Mack Chassis -Technical Service Bulletin M-284 - 068, Exhaust Particulate Sensor, Repair (2016 Vehicles)

Exhaust Particulate Sensor, Repair

V-284-068

(October 2020)

Repair 1

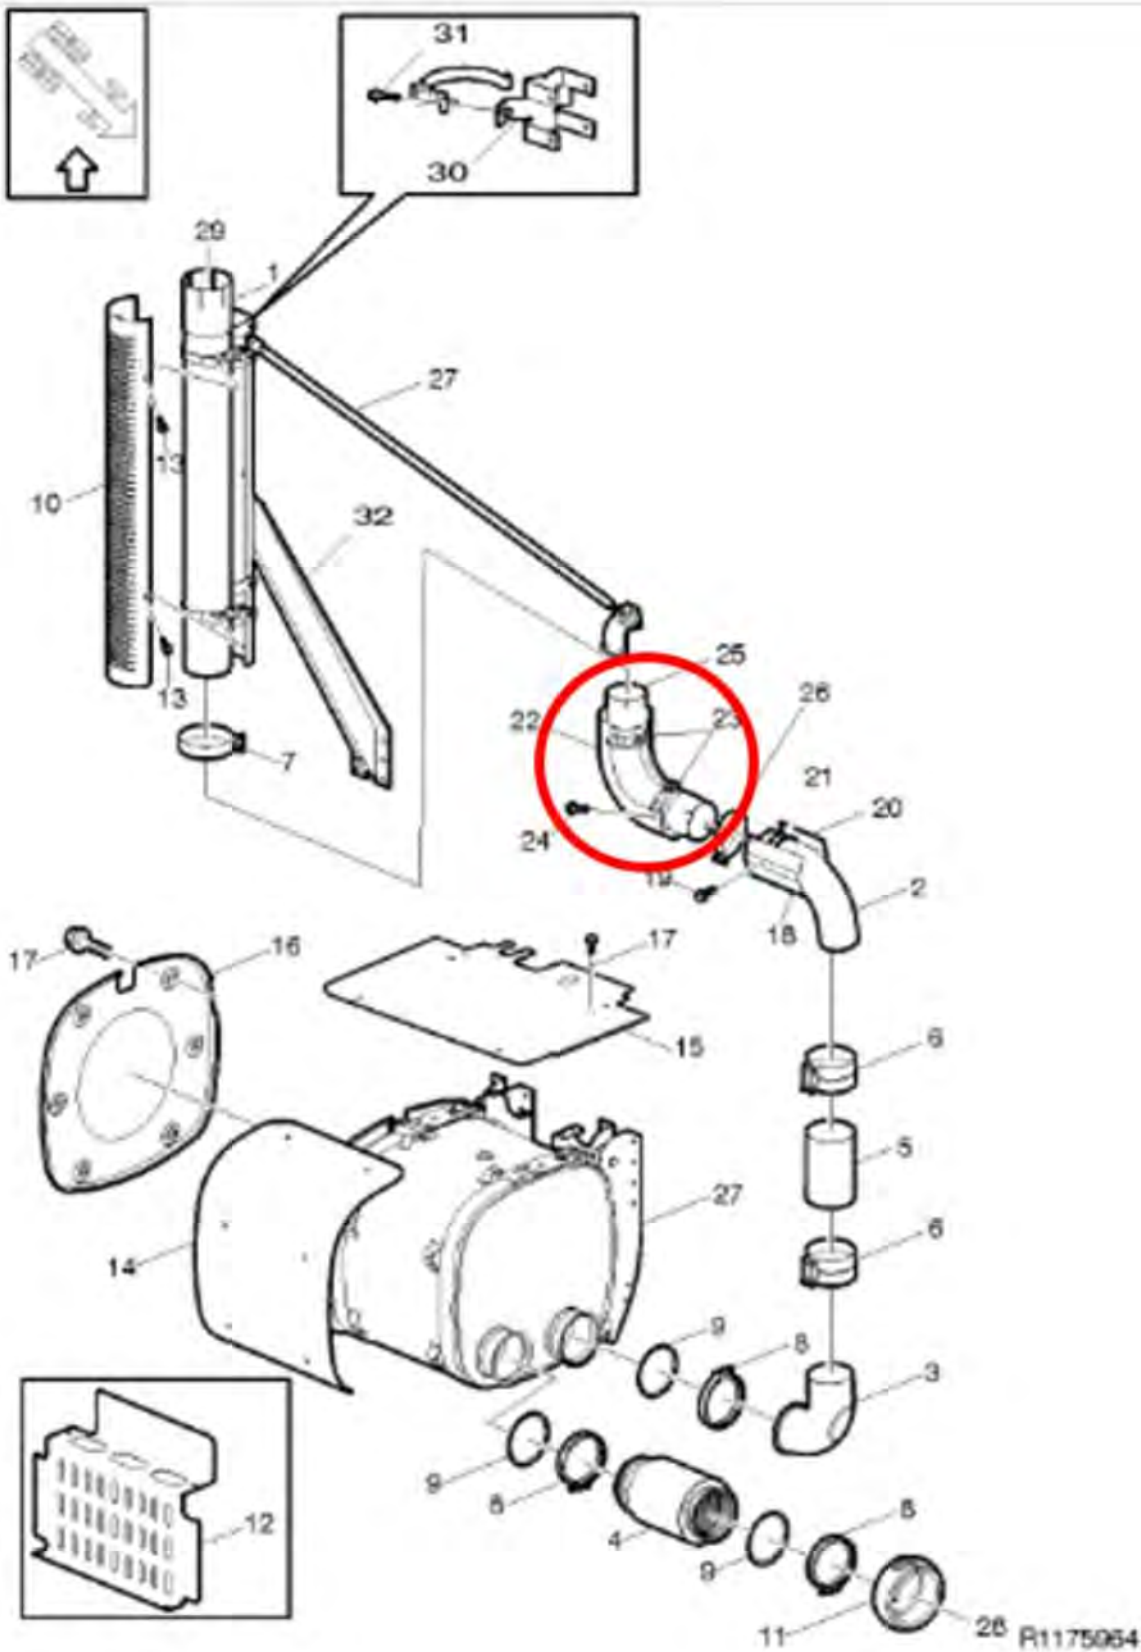
Model	Cab Type	Exhaust Configuration	Pipe 1
VNL	Day Cab	Single Outlet Right Side Outboard	(Not Bright) 23154798 (Bright) 23154799

Note: If the original flex pipe has previously been replaced, you will need a new elbow in addition to the new flex pipe.

Model	Cab Type		Elbow
VNL	Day Cab	Single Outlet Right Side Outboard	21274193

Repair 2

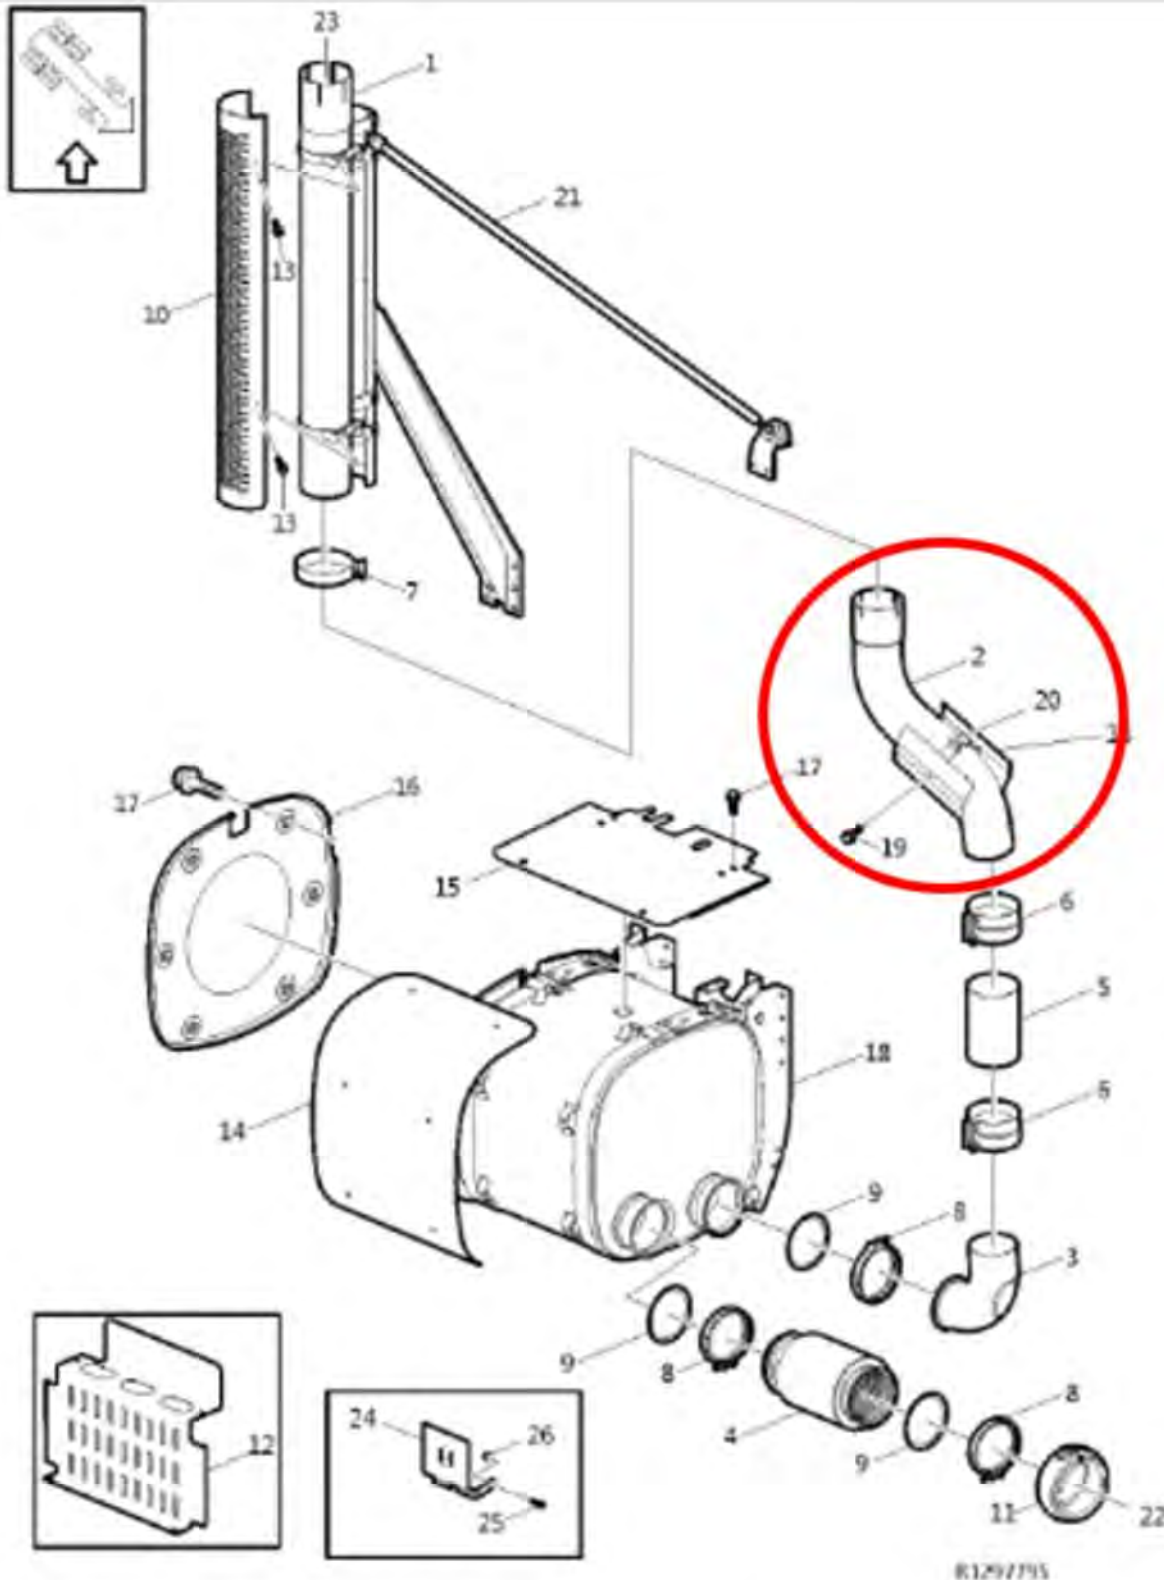
Model	Cab Type	Exhaust Configuration	Pipe 1
VNM/VHD	Day Cab	Single Outlet Right Side Inboard	23630037

Repair 3

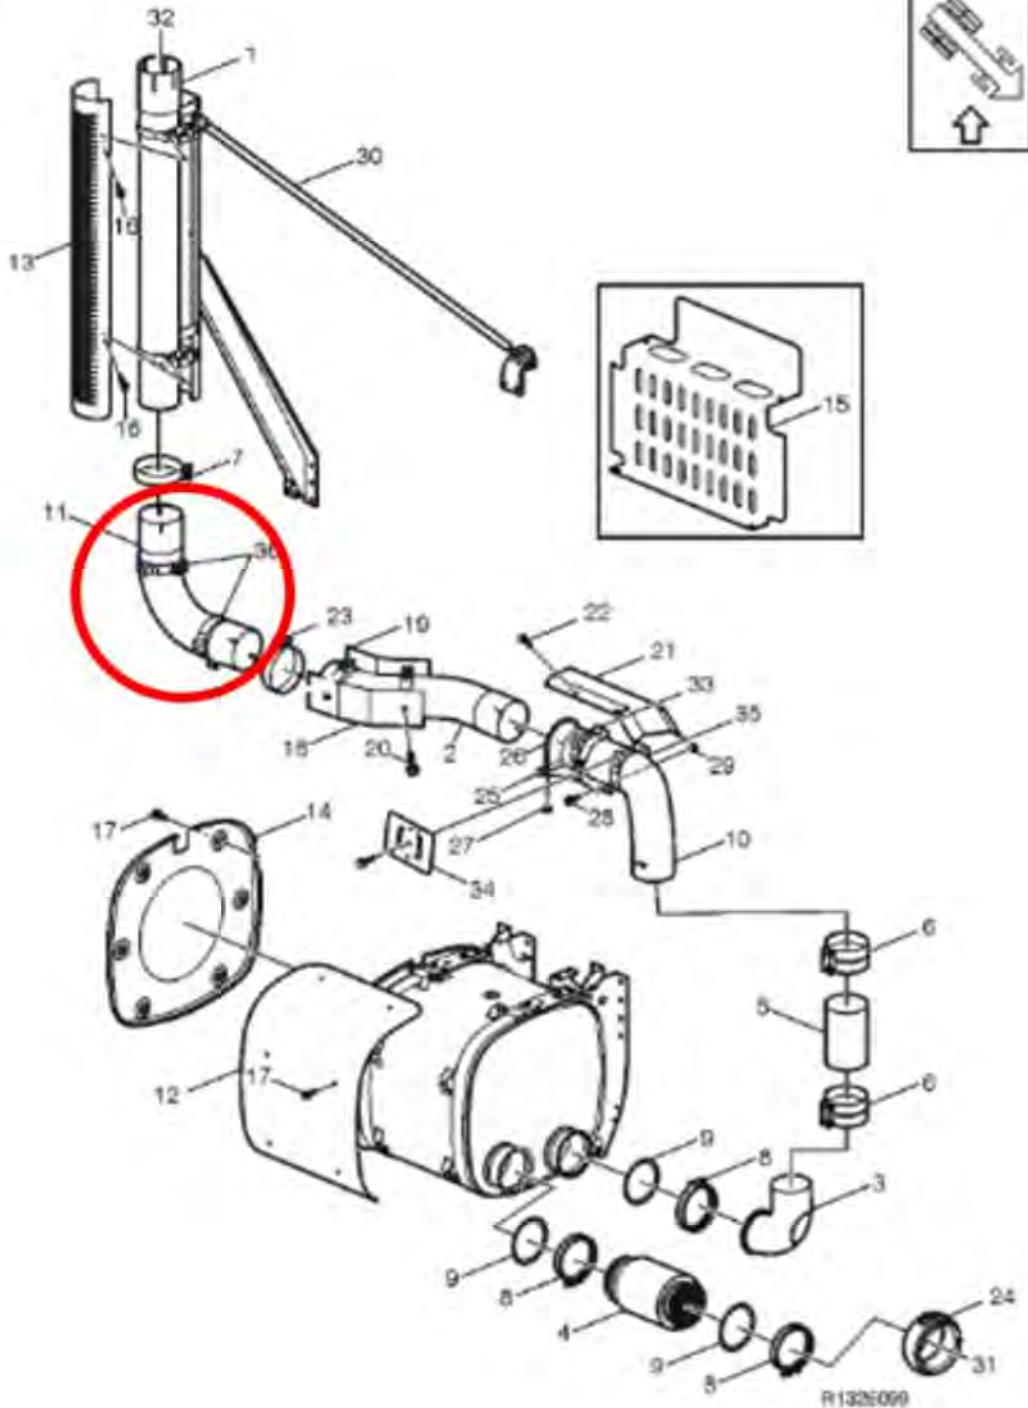
Model	Cab Type	Exhaust Configuration	Pipe 1
VNL/VHD	430/630 Sleeper	Single Outlet Right Side Inboard	(Not Bright) 23154798

Note: If the original flex pipe has previously been replaced, you will need a new elbow in addition to the new flex pipe.

Model	Cab Type	Exhaust Configuration	Elbow
VNL/VHD	430/630 Sleeper	Single Outlet Right Side Inboard	21687278

Repair 4

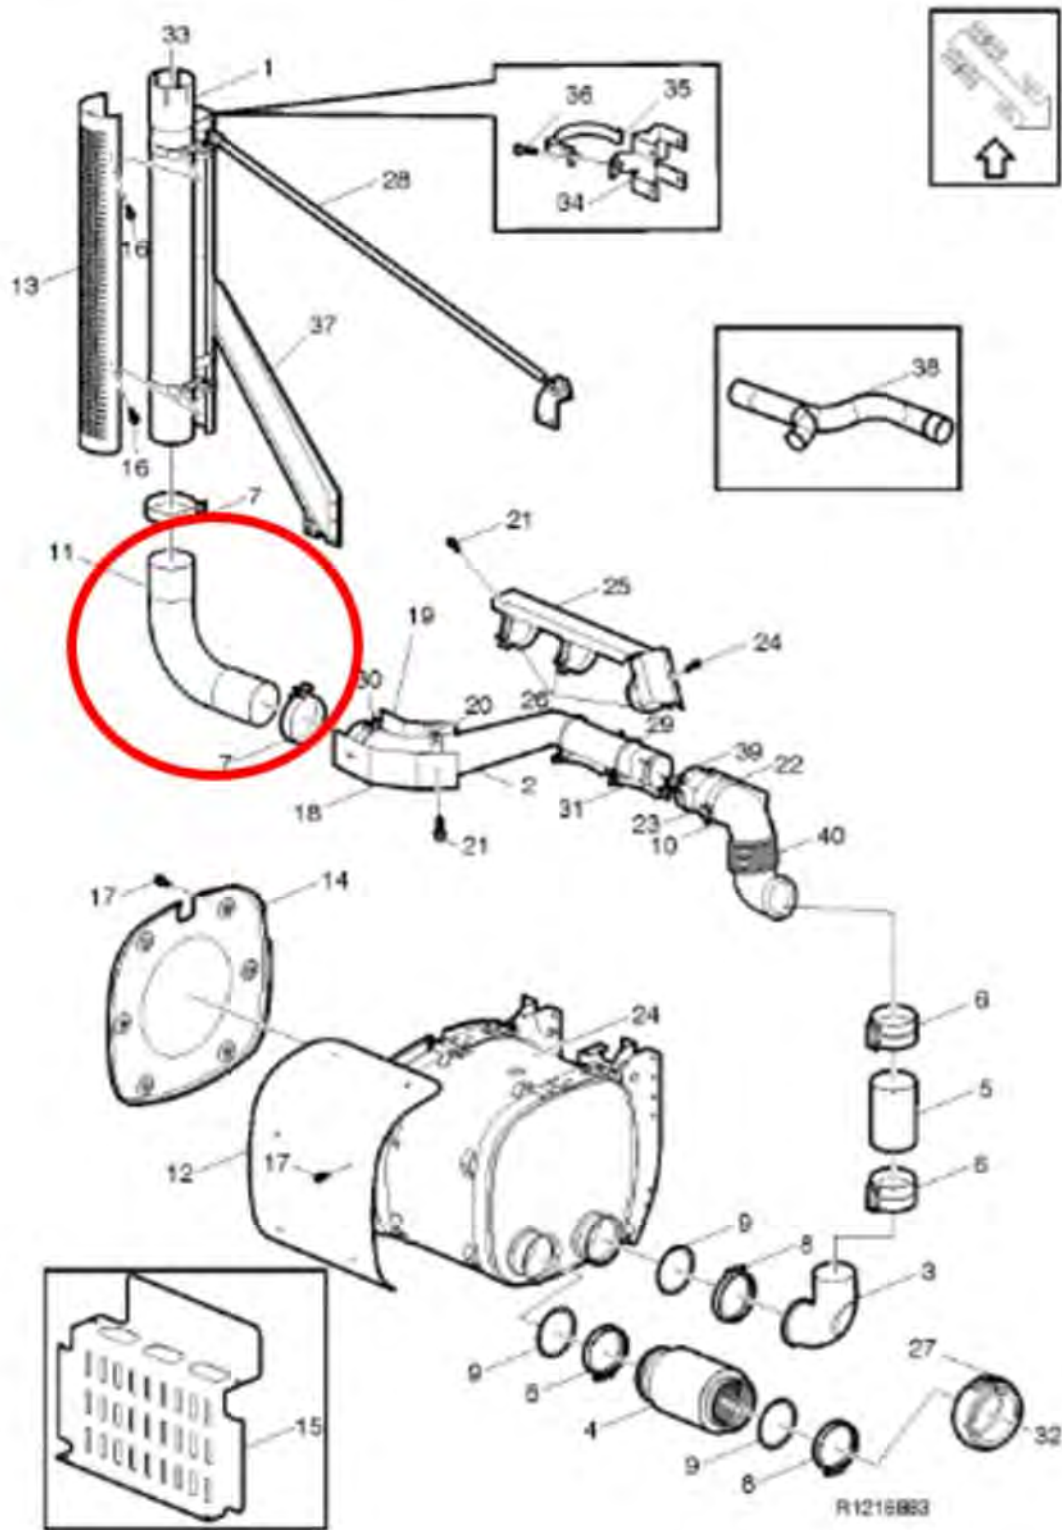
Model	Cab Type	Exhaust Configuration	Pipe 1
VNL	430/670/780 Sleeper	Single Outlet Right Side Inboard	(Not Bright) 23154798 (Bright) 23154799

Note: If the original flex pipe has previously been replaced, you will need a new elbow in addition to the new flex pipe

Model	Cab Type	Exhaust Configuration	Elbow
VNL	430 Sleeper	Single Outlet Right Side Inboard	21625282

Model	Cab Type	Exhaust Configuration	Elbow
VNL	670/780 Sleeper	Single Outlet Right Side Inboard	21625281

Repair 5

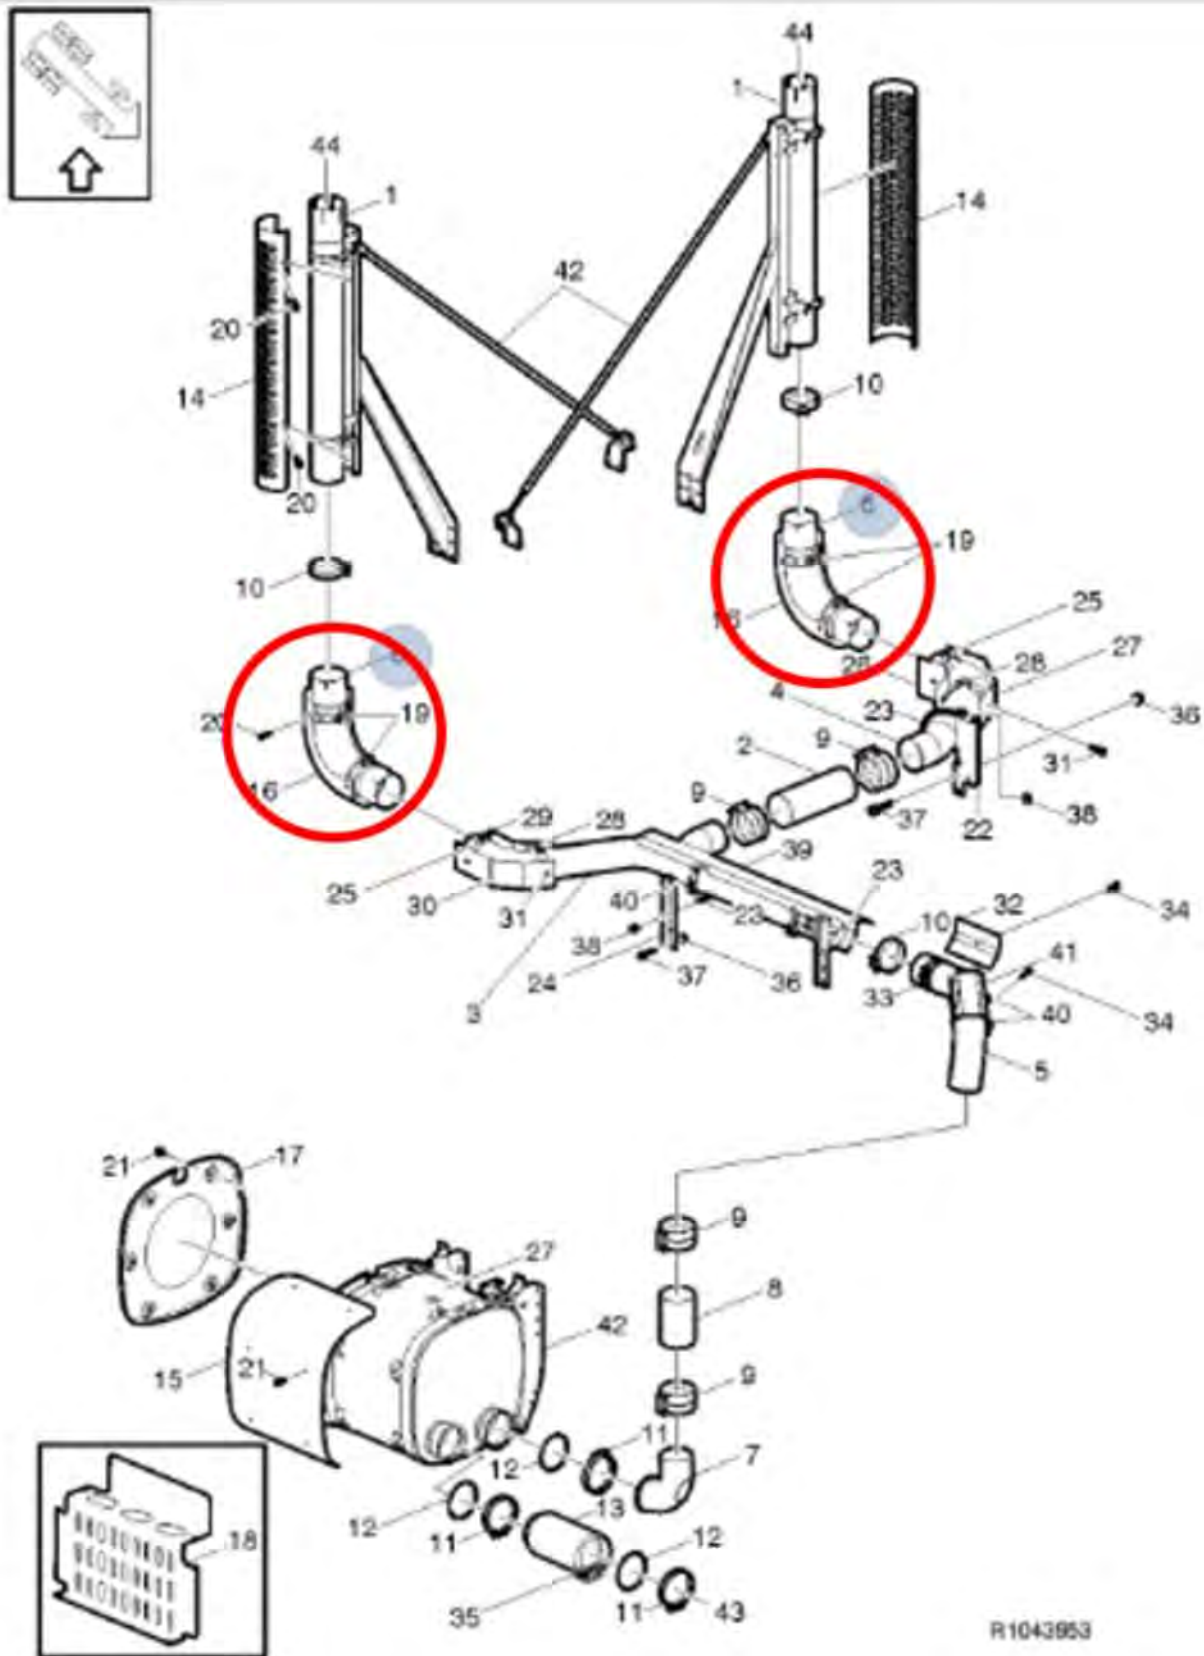
Model	Cab Type	Exhaust Configuration	Pipe 1
VNL	430/670/780 Sleeper	Single Outlet Right Side Inboard	(Not Bright) 23154798 (Bright) 23154799

Note: If the original flex pipe has previously been replaced, you will need a new elbow in addition to the new flex pipe

Model	Cab Type	Exhaust Configuration	Elbow
VNL	430 Sleeper	Single Outlet Right Side Inboard	21625282

Model	Cab Type	Exhaust Configuration	Elbow
VNL	670/780 Sleeper	Single Outlet Right Side Inboard	21625281
